Report to the Secretary's delegate on an application for a site compatibility certificate (SCC2020WILLO-1) under State Environmental Planning Policy (Affordable Rental Housing) 2009 – 34 Fullers Road, Chatswood

Figure 9: West and east elevations showing stepped format of the proposed development (Source: SCC report, J Yang).

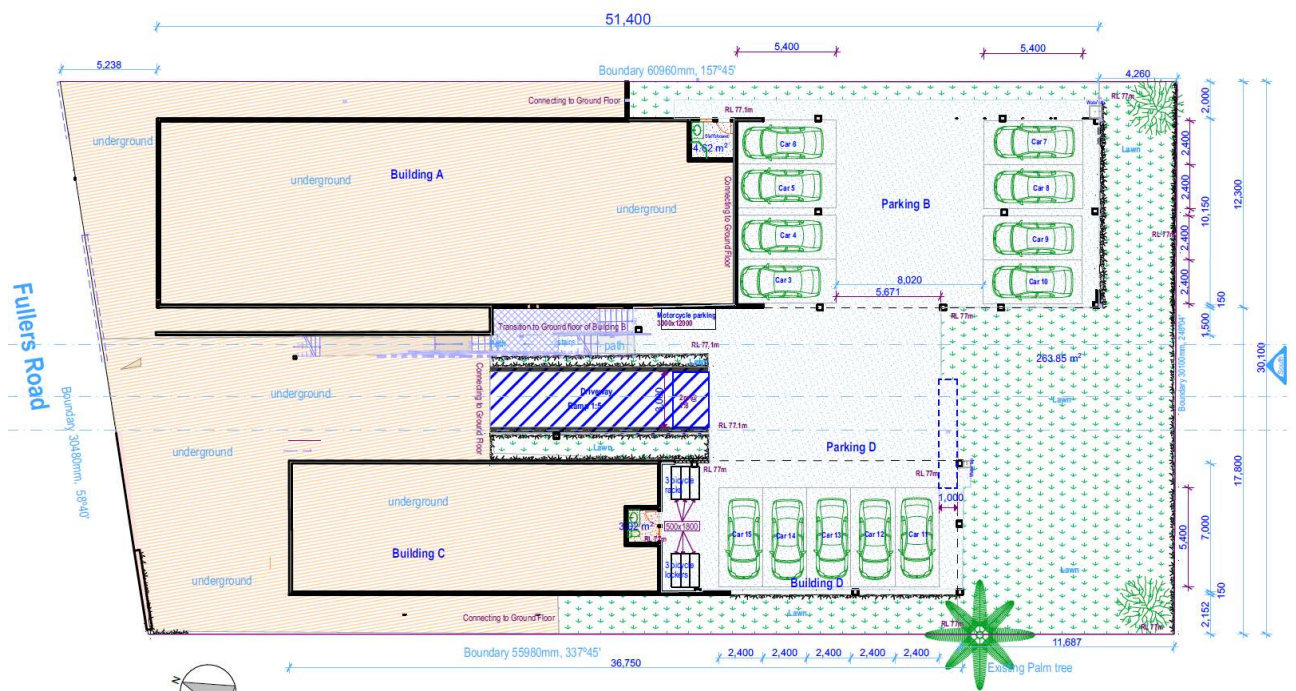
The Department considers the proposal is 3 storeys (refer to elevations at **Figure 9**) and therefore triggers the application of SEPP 65 and the ADG.

Figure 14: Ground floor plan showing proposed setbacks to Fullers Road (Source: SCC report, J Yang).

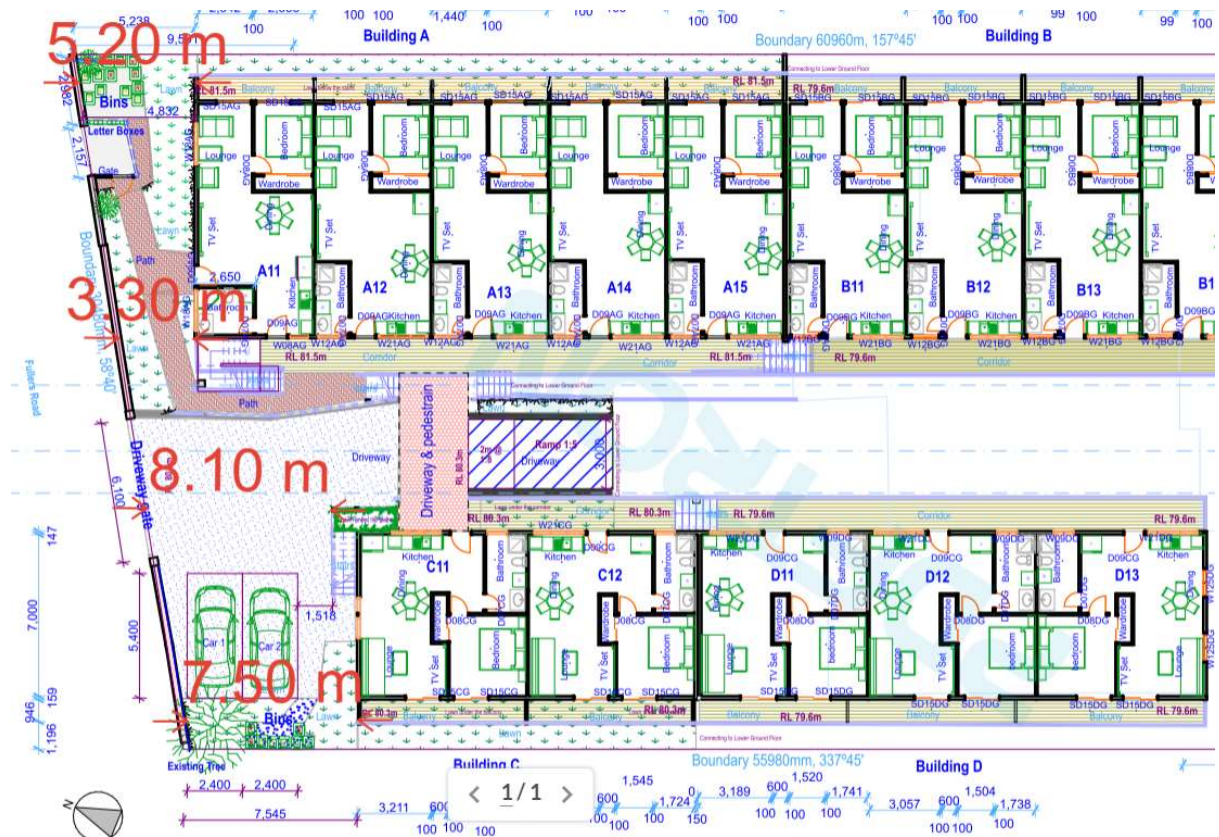
The plans propose front setbacks of between 5.2m and 3.3m for Building A (eastern building) and between 7.5m to 8.1m for Building C (western building) (**Figure 14**).

The proposed front setbacks are notably less than the existing front setback on site which is at a minimum of 9m and are inconsistent with adjoining sites which have a minimum front setback of approximately 6m.

It is also noted that the front setback of Building C (western building), where the front setback is at its greatest, is proposed to comprise a paved driveway and two

car parking spaces. This would further limit the ability for the front setback to support landscaping and tree growth to match the existing streetscape and potentially mitigate the bulk and scale of the proposal.

The Department considers the proposed front setbacks are inconsistent with the general street character and landscaped setting. Other dwellings along Fullers Road have a greater minimum setback overall.
